**RE: 8261 HWY 50, VAUGHAN, ON – PROPOSED RETAINING WALL ENCROACHMENT**  
**(A160/22 - REQUEST FOR ADJOURNMENT)**

**Re: Engineering Opinion (r1) – Proposed Retaining Wall  
ZZEN Vultra Storage Facility, 8261 Hwy 50  
Vaughan, ON**

Figure 1 - SK-2 by LMS encroachment per SP-1 wall layout

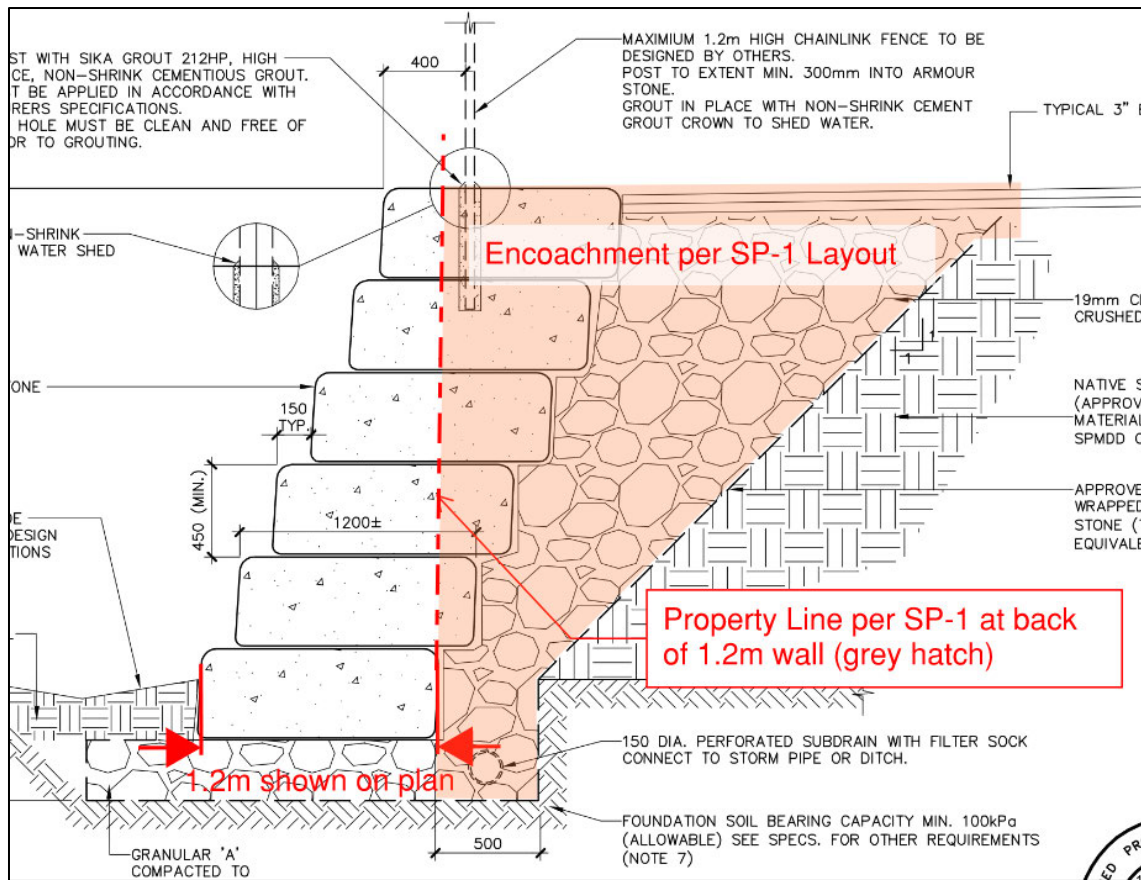
### UEL Drawing SP-1 Misrepresents the Retaining Wall Dimensions

UEL Drawing SP-1 misrepresents the depth of the retaining wall in their plan view drawing. The plan view depicts a shaded (grey) area that is scaled (1:250) to be approximately 1.2m deep. The back of the 1.2m wall shown on the plan is at 0.0m zero clearance from the property line. Drawing SP-1 includes a structural sealed design for a “Typical Armour Stone Retaining Wall (SK-2)” by LMS Engineering Inc. dated October 2021. This detail limits the height of the wall to 1.8m finished exposed height. The wall is designed with armourstone block which are denoted as 1.2m depth and a 0.15m setback for each armourstone. Therefore, the actual finished depth from plan view would range from 1.5m (1.0m height with 2 step backs at 0.15m each) to 1.8m (1.8m high wall with 4 step backs at 0.15m each). This results in a permanent encroachment of the armourstone onto the Anatolia property up to 0.6m.

Figure 2 - SEC-2 Cross-Section at Anatolia property

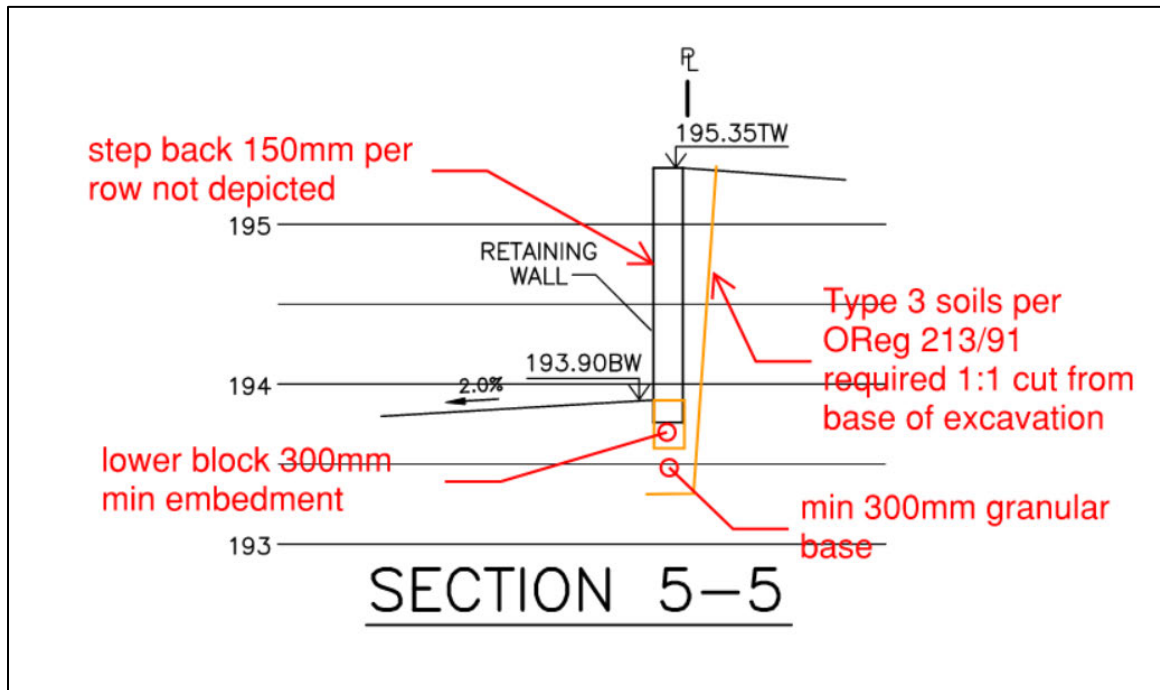
## SEC-2 Cross-Sections do not match SP-1

Section 5-5 and 6-6 from drawing SEC-2 represent the retaining wall along the Anatolia property line. The retaining wall depicted omits the 0.15m set back per block row as shown on SK-2 design; therefore the actual wall if constructed to match SK-2 may permanently encroach on the Anatolia property line, including the drainage granulars and subdrain behind the wall. Furthermore, SEC-2 confirms that the total cut of minimum 2.05m would be required to construct the wall, resulting in grading impacts to the Anatolia property to accommodate O.Reg. 213/91 requirements for construction safety.

Figure 3 - Property Encroachment per UEL Drawing SP-1 & LMS SK-2

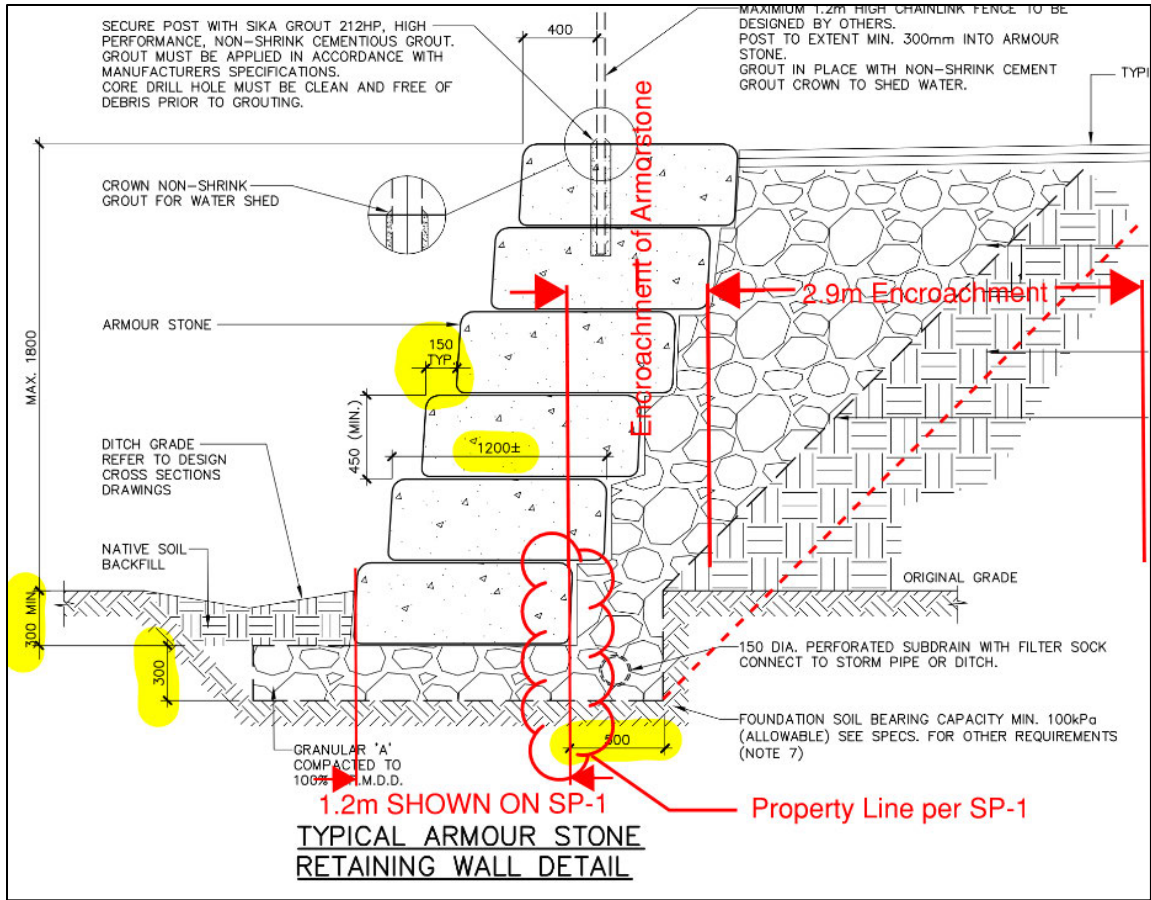
UEL omits construction grading details within the SP-1 drawing to depict the necessary grading to construct the wall in accordance with the LMS detail at SK-2. Furthermore, the typical retaining wall sketch by LMK misrepresents the excavation limits behind the retaining wall required to meet the legal requirements of Ontario Regulation (O.Reg.) 213/91 for safe excavation.

The temporary excavation required to construct the retaining wall would encroach up to 2.9m onto the Anatolia property based on the shown layout, as follows; The excavation would occur within soils classified as Type 3 soils per O.Reg. 213/91. Type 3 soils require a 1:1 sloped excavation under the Regulations from the bottom of the excavation. The vertical excavation required to construct the wall would be up to 2.4m in height. Therefore, from the back of the 1.2m deep armourstone block (SP-1 alignment at 0m setback to property line) the 0.5m wide subdrain trench plus the 2.4m cut at 1:1 slope would total 2.9m encroachment on the Anatolia property. In addition, the LMS typical detail incorrectly depicts a vertical excavation at the base of the wall, which would not be permitted under O.Reg. 213/91 for Type 3 soils – the backslope of 1:1 would need to be from the base of excavation to meet O.Reg. 213/91 requirements.

Therefore, the back of the wall is required to be located 2.9m from the Anatolia property line to accommodate safe excavation under O.Reg. 213/91. This results in a total offset from property line to the front face of the wall of 4.1m (1.2 deep armourstone plus 2.9m excavation).
